## HISTORIC AND DESIGN REVIEW COMMISSION

October 19, 2016

**HDRC CASE NO:** 2016-405  
**ADDRESS:** 516 PIERCE  
**LEGAL DESCRIPTION:** NCB 1260 BLK LOT 47  
**ZONING:** undefined  
**CITY COUNCIL DIST.:** 2  
**DISTRICT:** Government Hill Historic District  
**APPLICANT:** Robert Mota  
**OWNER:** Robert Mota  
**TYPE OF WORK:** Installation of front and side yard fencing  
**REQUEST:**

The applicant is requesting a Certificate of Appropriateness for approval to install a front and side yard fence wood picket fence to be 3' – 6" in height at 516 Pierce.

# Example

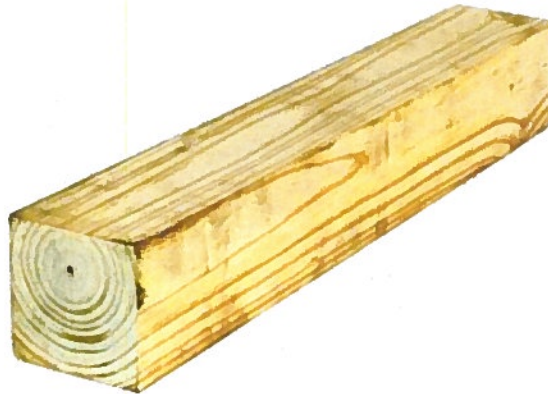
- a. The applicant has proposed to install a front and side yard fence at 516 Pierce in the Government Hill Historic District. According to the Guidelines for Site Elements 2.B.ii., new fences should be introduced within districts that historically feature front yard fences. Front and side yard fences are frequently found throughout Government Hill. The applicant's proposal is appropriate and consistent with the Guidelines.
- b. According to the Guidelines for Site Elements 2.B.i., new fenced should appear similar to those used historically within the district in terms of their scale, transparency and character. Additionally, fences should feature designs

that are complementary of the historic structure on the property. The applicant has proposed to install a wooden, white picket fence to span a total length of 110 feet to front both Pierce Avenue and Quitman Street. The applicant has proposed an overall height of 3' – 6". This is consistent with the Guidelines.

Staff recommends approval as submitted based on findings a and b.
